STAFF RECOMMENDATION
1721 5th Avenue North
November 20, 2013

Application: New construction--infill
District: Salemtown Neighborhood Conservation Zoning Overlay
Council District: 19
Map and Parcel Number: 08108046200
Applicant: Gail Wales, owner
Project Lead: Melissa Baldock, melissa.baldock@nashville.gov

<p>Description of Project: Application is to construct a duplex on a vacant lot.</p> <p>Recommendation Summary: Staff recommends approval of the duplex infill with the following conditions:</p> <ol style="list-style-type: none"> 1. The house be pushed forward on the lot so that its front porch lines up with the house next door at 1719 5th Avenue North. 2. Staff review and approve the materials for the porch columns, porch floor, and foundation. 3. Staff review and approve all window and door selections prior to purchase and installation. 4. Staff review and approve the roof shingle color. 5. The HVAC unit be placed at the rear, or on a side façade beyond the midpoint of the house. <p>With these conditions, staff finds that the project meets Section III of the <i>Salemtown Neighborhood Conservation Zoning Overlay Handbook & Design Guidelines</i>.</p>	<p>Attachments A: Photographs

1 Site Plan
1" = 20'-0"

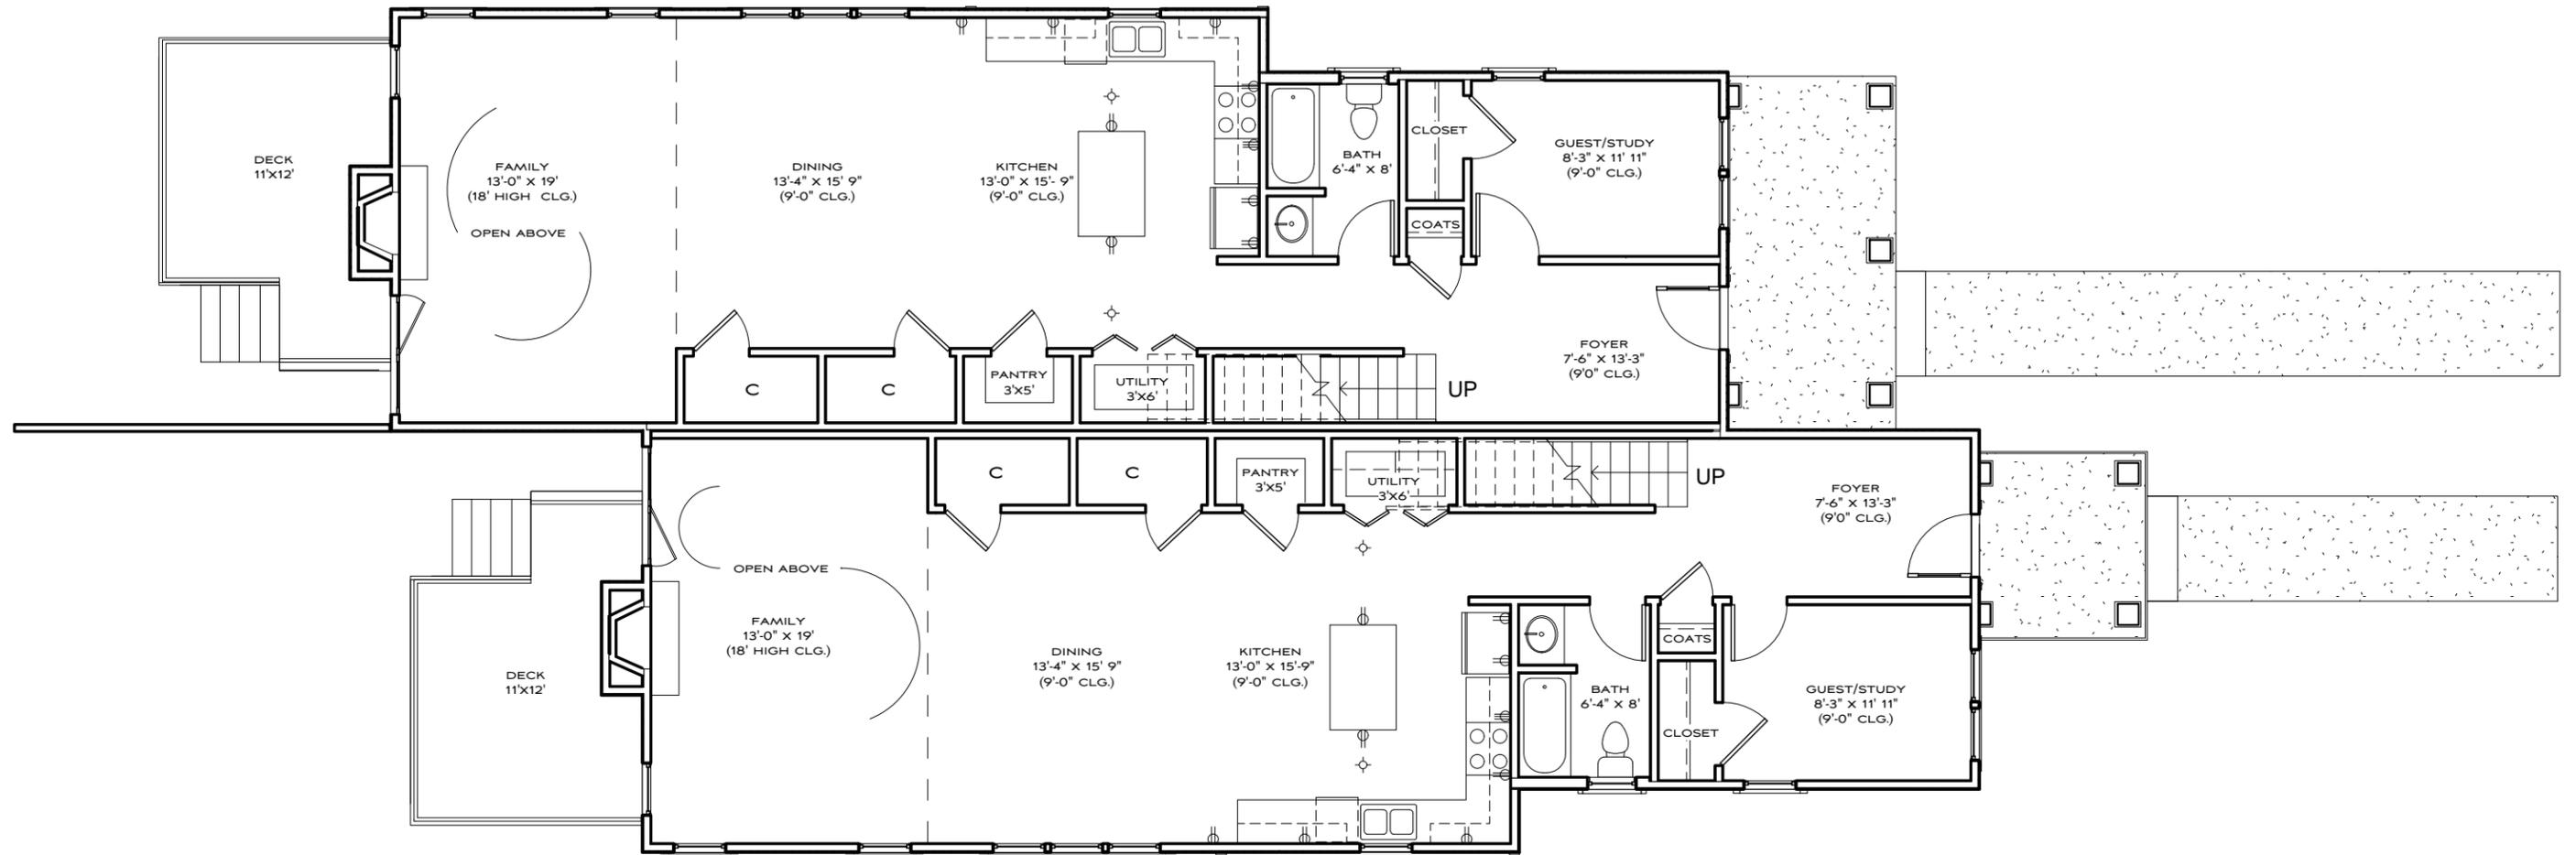
Setback & Rhythm of Spacing. The proposed infill will be centered on the lot and will meet all base zoning setbacks. At the front, the structure will be eight feet (8') from each of the side property lines, although further back, the width of the structure expands so that it is five feet (5') from the side property lines. This allows for a more appropriate rhythm along the block face, while allowing for larger units.

The front porch on the left side will be set twenty feet (20') from the front property line. By comparison, the one-story structure at 1723 5th Avenue North is just seven feet (7') from the front property line, and the one-story structure at 1719 5th Avenue North is approximately sixteen feet (16') from the front property line. Staff recommends that the new infill have a similar front setback to the structure at 1719 5th Avenue North, so that the line of the front porch of the duplex's left unit lines up with the front wall and porch of No. 1719. With the adjustment of the front setback, staff finds that the duplex's setback and rhythm of spacing meet Section III.C. of the *Salemtown Neighborhood Conservation Zoning Overlay: Handbook & Design Guidelines*.

Accessory Structure. The site plan indicates that a twenty-four foot by twenty-four foot (24' X 24') garage may be proposed in the future. The current project does not include any accessory structures.

Utilities. The location of the infill's HVAC units is not indicated on the plans. Staff asks that they be located at the rear, or on a side façade beyond the midpoint of the house.

1. The house be pushed forward on the lot so that its front porch lines up with the house next door at 1719 5th Avenue North.
2. Staff review and approve the materials for the porch columns, porch floor, and foundation.
3. Staff review and approve all window and door selections prior to purchase and installation.
4. Staff review and approve the roof shingle color.
5. The HVAC unit be placed at the rear, or on a side façade beyond the midpoint of the house.
